March 16, 2009

This letter is in response to the three questions contained in your email of March 2, 2009 regarding "Application for Risk-Based Cleanup of Soil at Haley's Ditch" dated January 9, 2009. Your questions are highlighted in bold followed by Lockheed Martin's response.

Restored Channel Schematic

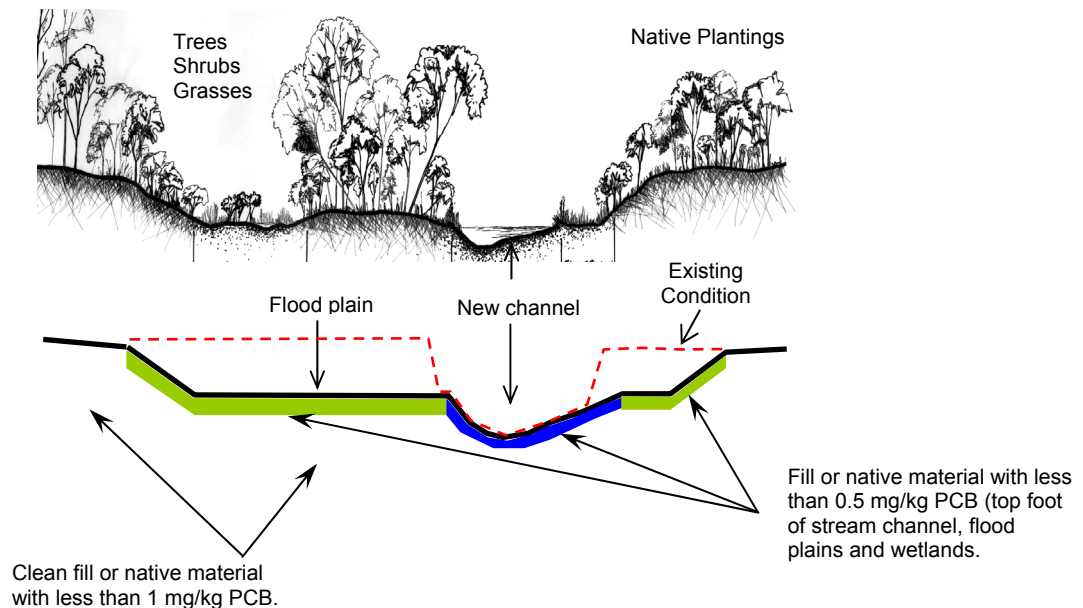
1) Clean Fill PCB Concentrations: It is stated in the Executive Summary (page i) and in Section 2 that "The excavation areas, except the stream channel and wetlands, will be backfilled, as needed, with soil containing less than 1 mg/kg total PCBs. The restored stream channel and wetland areas will be covered with clean fill material containing less than 0.5 mg/kg PCBs." The soil cleanup action level is 1 mg/kg whereas the cleanup action level is less than 0.5 mg/kg PCBs for Haley's Ditch sediment. Setting the cleanup action levels and the clean fill material levels to the same values does not provide adequate "buffer" to account for sampling uncertainties and to ensure recontamination does not occur. Dave mentioned the possibility of reusing some of the fill material removed as part of the remediation activities instead of having to bring in all new fill. Ohio EPA cautions against reusing PCB contaminated fill material from the site due to sampling uncertainties and the potential for recontaminating remediated areas. It is recommended that imported clean fill, which has been tested to be generally nondetect for PCBs, be used for restoration activities.

- The cleanup standard for this project is 1 mg/kg total PCB.
- Remove all soft sediments from the streambed.
- Collect verification samples from the soil remaining after the streambed sediments are removed and continue to excavate until results are less than 1 mg/kg.

- Create a sub-grade for the stream channel and potentially wetted areas by relocating soils with less than 1 mg/kg total PCB within the project area, or importing soils with less than 1 mg/kg total PCB, as needed.

- Create a final grade in the stream channel with a one-foot thick top layer of sand, gravel, stone and other appropriate materials for erosion control having a total PCB concentration of 0.5 mg/kg or less.

- Create a final grade in potentially wetted areas including the flood plain areas and wetlands with a one-foot thick top layer of soil or other materials as appropriate having a total PCB concentration of 0.5 mg/kg or less.
